**MEMORANDUM**

**Date:** April 12, 2019

**Subject:** RZN19-0001/ORD 1892-Request to rezone 5.550 acres in the R-5 Transitional Residential and GC General Commercial Zoning Districts to PR Planned Residential Zoning District on the 1000 block of North Main Street (Tax Map Nos 226-20 9-11; 226-A 284-290; 226-A 293; 226-3 1-4) for the development of a mixed use multi-family and commercial development by John Neel of Gay and Neel, Inc. (applicant) for Landmark Properties, Inc. (contract purchaser).

Contextual Site Plan

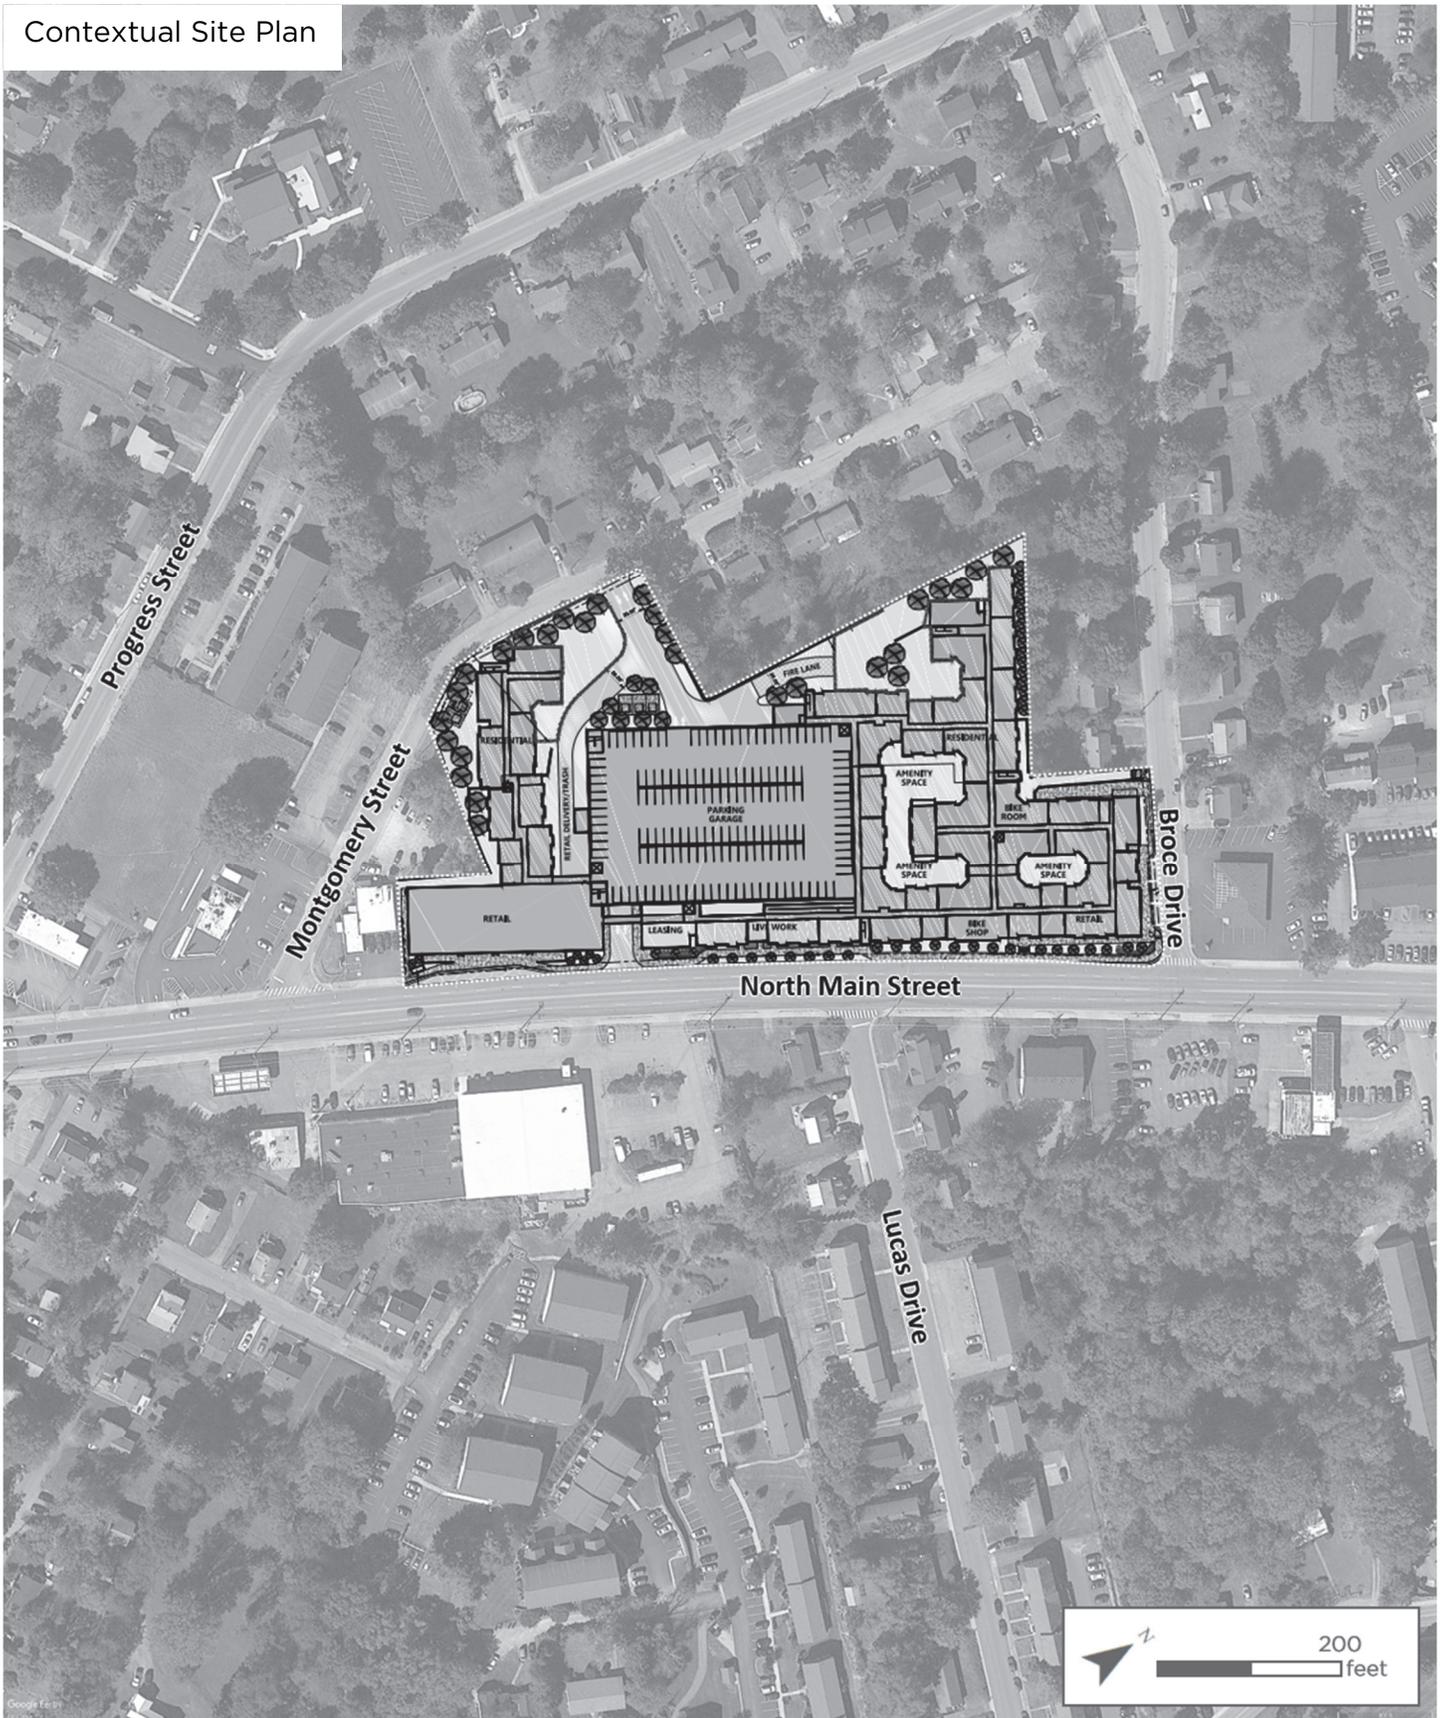
Fifteen parcels of land are being assembled to create a 5-acre site for The Standard mixed-use project. The developer plans to demolish all of the structures contained therein and construct a large mixed-use project which consists of a maximum of 825 bedrooms and 17,800 square feet of commercial space wrapped around a multi-story parking garage.

Most of the commercial space is in one large 13,800 square foot tenant space on the south corner of the site. The space is designed for a single user and the owner lists possible tenants as a small grocer or soft good retailer. The rest of the commercial space is on the opposite corner of the building and is separated into approximately four smaller leasable spaces. The remainder of the North Main Street frontage is filled with the leasing office, live-work space, and residential uses.
